DRAWN Gary Swift TUNL	2/19/2021	SoLID HGC		
1-919-660-2668				
Material: Alum 6061-T6		TITLE Proto Assembly Shell 20210219 Notes		
Unless Otherwise Specified Tolerances are: .xx = ± .01 Angles = ± 0.1' .xxx = ± .005	Break Sharp Edges: 0.010			
Dim in Inches		SIZE B	DWG NO 20210219 Tank Proto Fab notes	REV
		SCALE 0.08 : 1	SHEET 1 OF 1

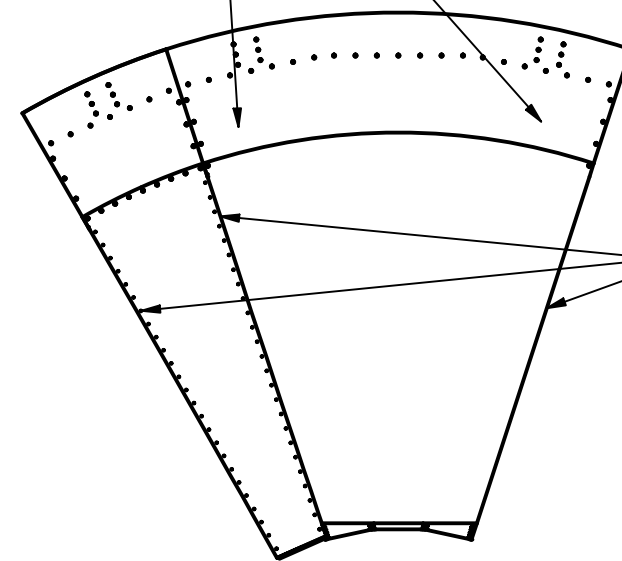
For Thin Window Pattern:
 Include squared corners to support
 the outer clamp frame. Include clearance
 holes for Shell bolts (not shown).

During Proto assembly:
 Window mount holes on arc) were moved in about 1" on radius.

Back Window sequence:
 For future fabrication, put the
 tapped holes in the shell frame
 parts during initial CNC machining.
 Then transfer locations
 for window clearance holes
 during assembly.
